TECHNICAL BULLETIN

SUBJECT:
RELEASE OF SCDU III

TECHNICAL BULLETIN: 16-15
DATE: NOVEMBER 03, 2016

TRITON ANNOUNCES THE NEW SCDU III WITH INTEGRATED MAIN BOARD AND ULTRASONIC DOUBLE-DETECT SENSORS FOR ARGO AND TRAVERSE.

Option 1:

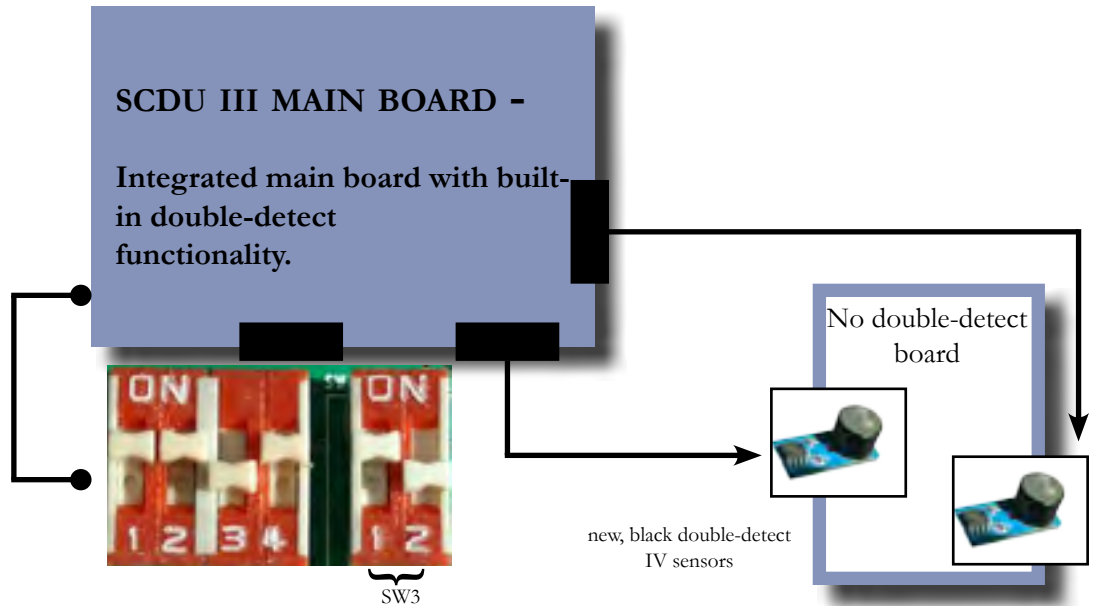
SW3 No. 1 position should be ON (up) for new, black sensors on SCDU III. When used with the previous, white sensors, SW3 No. 1 position on the new main board and SW1 No. 1 position on the double detect board should be OFF (down).

SCDU III

Option 2:

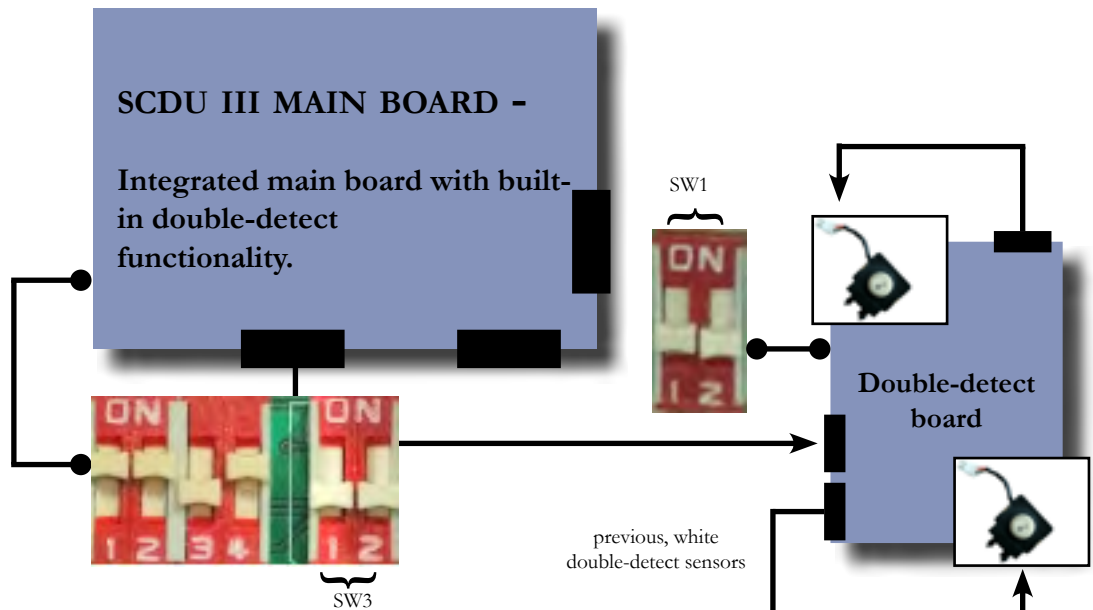
SCDU III main board is backward compatible for use with SCDU II double-detect board and large, white double-detect sensors.
